# ADDENDUM No. 1

#### To JASPER MASTER LIFT STATION

October 16, 2025

# JASPER, GEORGIA

# LIFT STATION & VALVE VAULT DETAILS: (#)

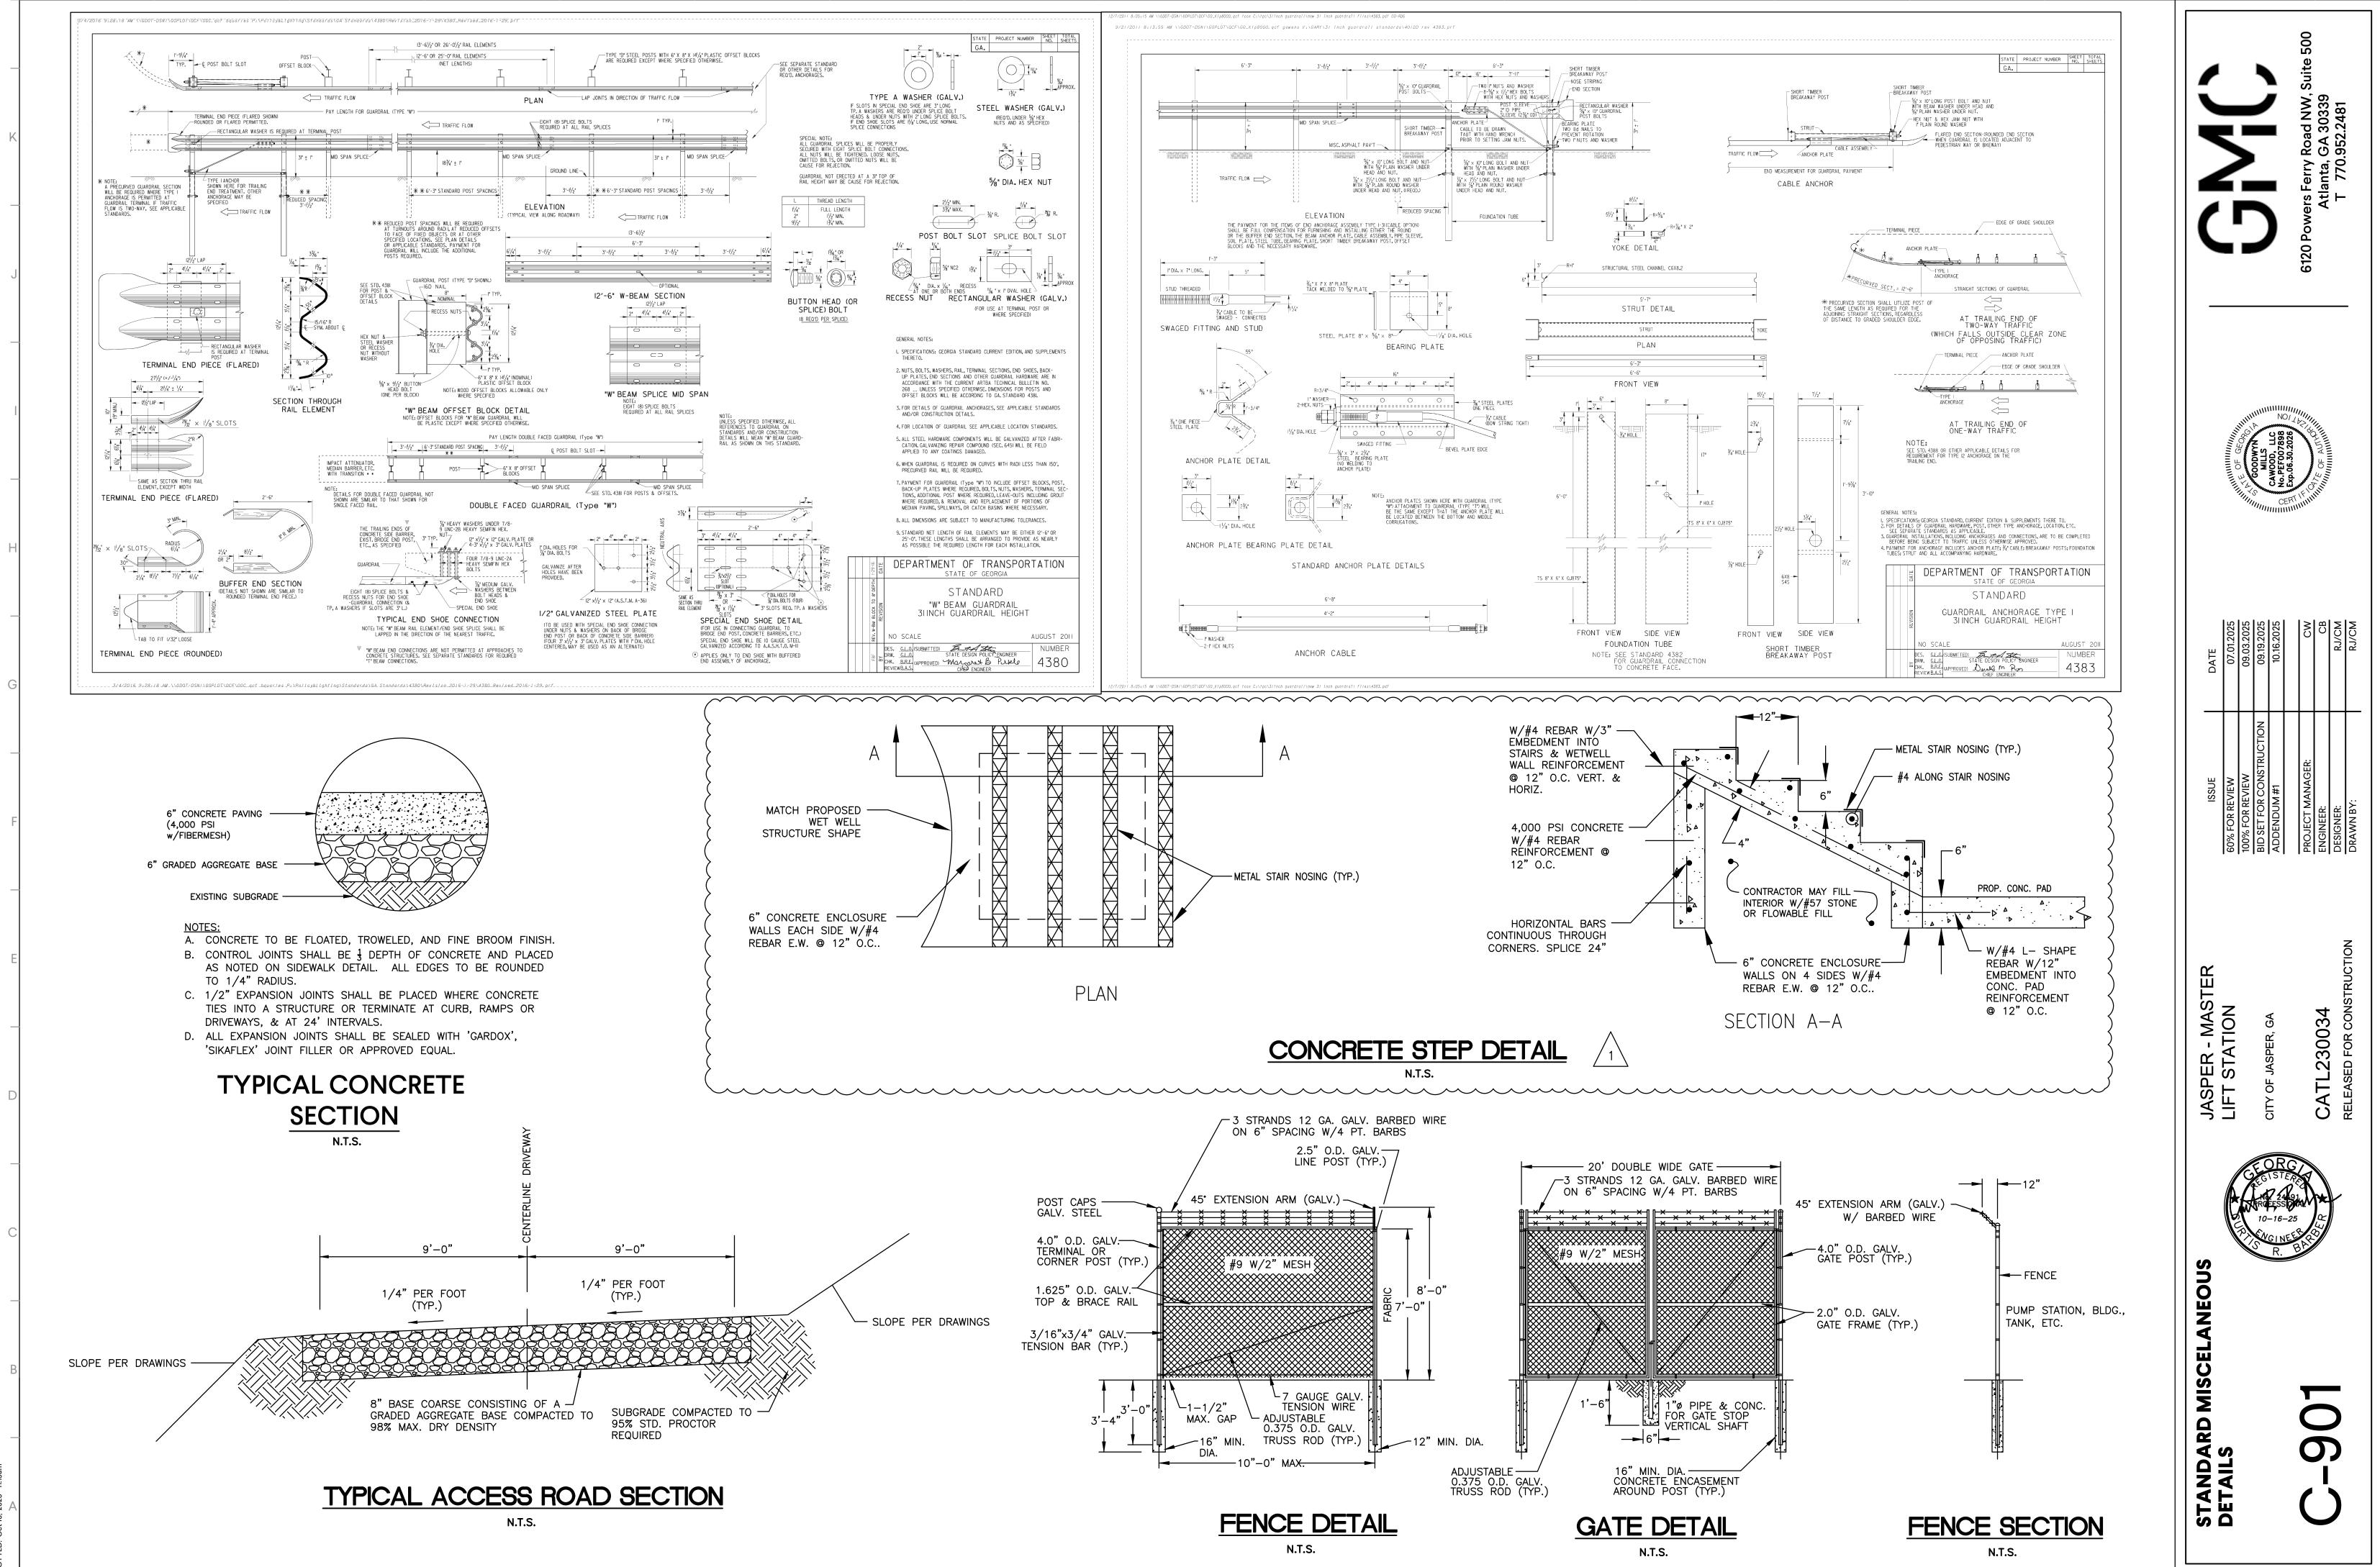
- 1. SECTION 43 25 13 SUBMERSIBLE CENTRIFUGAL PUMPS: Delete this section and replace with new SECTION 43 25 13 SUBMERSIBLE CENTRIFUGAL PUMPS attached. Changed the approved pump manufacturers.
- 2. Remove and replace sheets C-306, C-307, C-308 and C-901 with the revised sheets.

A. HOMA, Grundfos or Xylem.
